Coil config file parameter of Head coil and 9 inch coil contains wrong setting. Because of it, it is necessary to edit the parameter. This problem will be solved from M4 system.

2. Solution

EDIT COIL
ILLUSTRATION 2

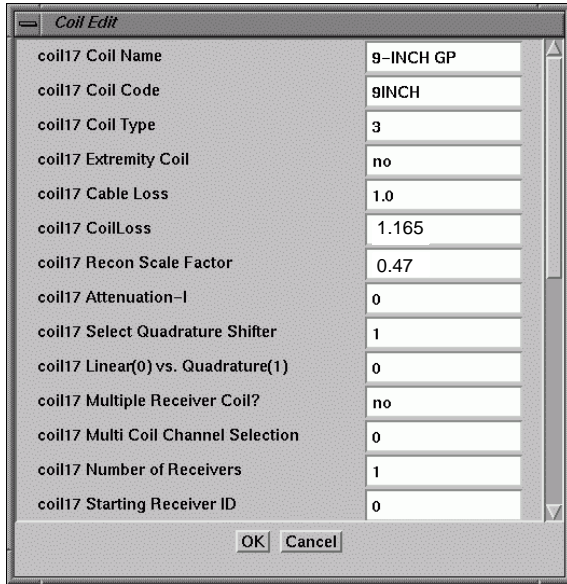
3. Edit the following parameter.

•**Head:** Linear(0) vs. Quadrature(1) 1(wrong) => 0(correct)

•**9 inch GP:** Linear(0) vs. Quadrature(1) 0(wrong) => 1(correct)
